FINAL PLAT OF
"HINDU TEMPLE ADDITION"
WICHITA, SEDGWICK COUNTY, KANSAS
IN THE NW 1/4 OF SECTION 22, T27S, R2E OF THE 6TH P.M.

SUB 2001-39 -- One-Step Final Plat of Reddi Addition

SUB 2000-39 -- One-Step Final Plat of Reddi Addition

CASE NUMBER: SUB 2001-39 -- REDDI ADDITION

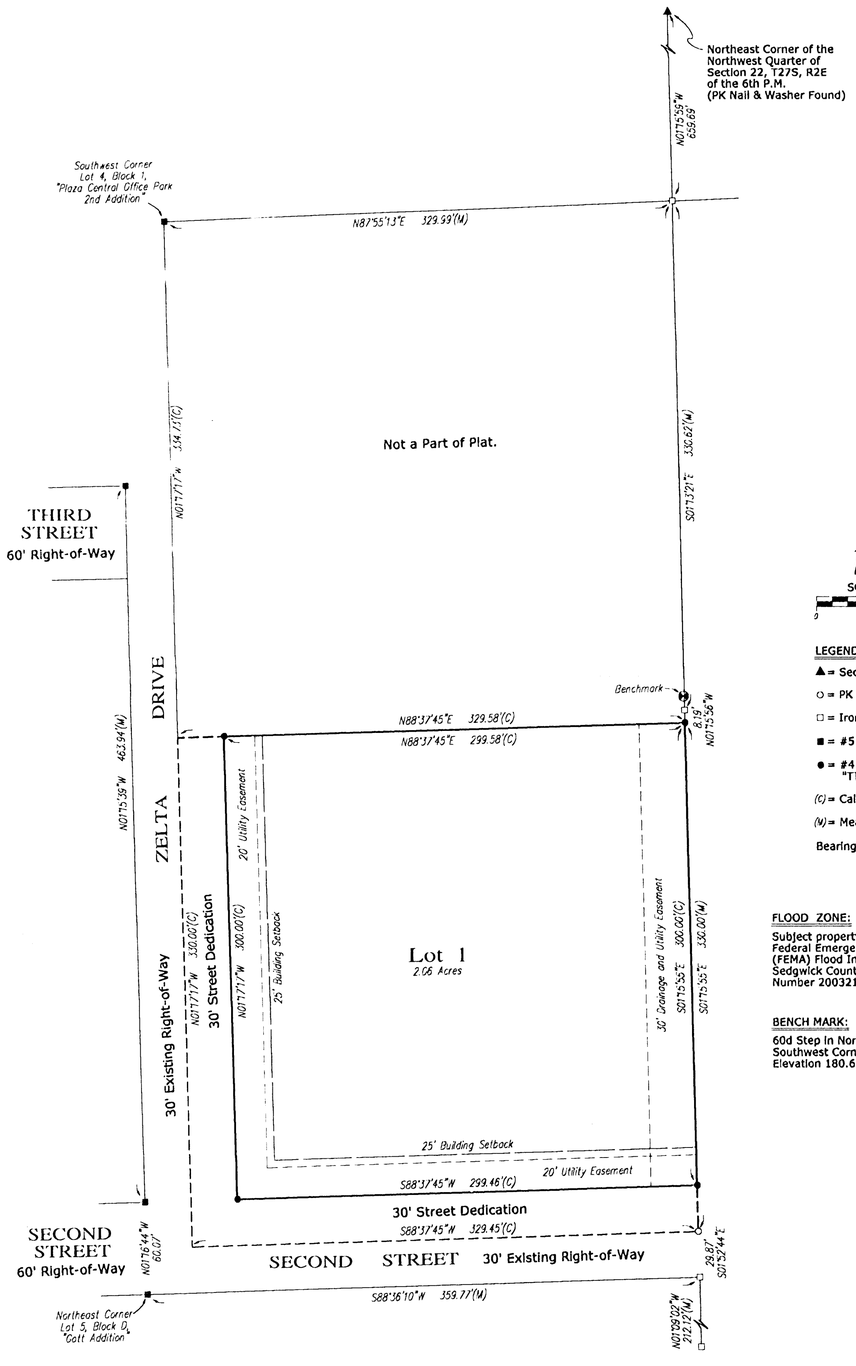
A. The applicant shall guarantee the extension of sanitary sewer to serve the lot being platted. This guarantee shall be with the City for service through the Four Mile Creek sanitary sewer system.

B. The applicant shall guarantee the extension of public water to serve the lot being platted.

D. City Engineering needs to comment on the status of the applicant's drainage plan. *The drainage plan is needed. An off-site drainage agreement is required.*

E. The applicant shall guarantee the installation of Second Street to a roadway width of 31-ft back of curb to back of curb.

F. The applicant shall provide a No Protest Agreement for future improvements to Zelta.

G. The paving guarantee shall include the installation of an "L" or "T" type turnaround at the terminus of Second Street at the plat's east line.

H. On the final plat, the MAPC signature block needs to reference "J.D. Michaelis, Acting Chair".

J. The plattor's text shall include language that a drainage plan has been developed for the plat and that all drainage easements, rights-of-way, or reserves shall remain at established grades or as modified with the approval of the applicable City or County Engineer, and unobstructed to allow for the conveyance of stormwater.

L. The applicant's engineer is advised that the Register of Deeds is requiring the name(s) of the notary public, who acknowledges the signatures on this plat, to be printed beneath the notary's signature.

P. Perimeter closure computations shall be submitted with the final plat tracing.
